Ducted Systems Technical Services: YS Letter

Letter: YS-002-22
Date: January 25, 2022
To: Ducted Systems (Factory Direct) S1 HVAC Branch Service, Sales, Warranty Managers
Ducted Systems (Applied) Distribution Service, Sales, Warranty Managers
Subject: **High Pressure Switch Failures**
Product/s: All current residential split system outdoor heat pump and air conditioning models (except HMM7) containing pressure switch S1-02546848000, S1-02547283000, S1-02550188000.
Effective: January 25, 2022 Expires: January 25, 2024
Summary: Labor and refrigerant allowance for replacement of a failed high pressure switch.

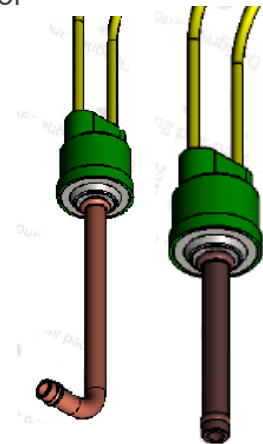
Dear valued customer,
we've received several complaints involving high pressure switch "stuck open" failures on many of our residential air conditioning and heat pump split system models. Vendor analysis of returned failed switches show most of the failures are due to moisture ingress into the switch contacts, however the entry point of the moisture points to the piping side of the switch. None of our switches are installed on unit piping with the switch piping pointing upwards. All our switches are installed with the wiring side up as shown in the image on the right.

All 3 switches are "auto-reset" and have a cut in (close) and cut out (open) pressure. It is important to test a switch by checking refrigerant circuit pressure and use an ohm meter to check for continuity. The switch open pressure is 650 psi. and the switch should automatically re-close at 450 psi. There is generally a +/- tolerance of 10 to 15 psi. Heat pump model units all contain defrost controls that can lock the equipment out for high pressure events. If a heat pump is experiencing high pressure faults, and the pressure switch is not stuck open, do not assume that the high pressure switch is faulty. In most cases, the switch is most likely performing its intended function. Make sure to check for proper indoor air flow first, then check unit charge using the heating charging charts in the outdoor unit installation manual.
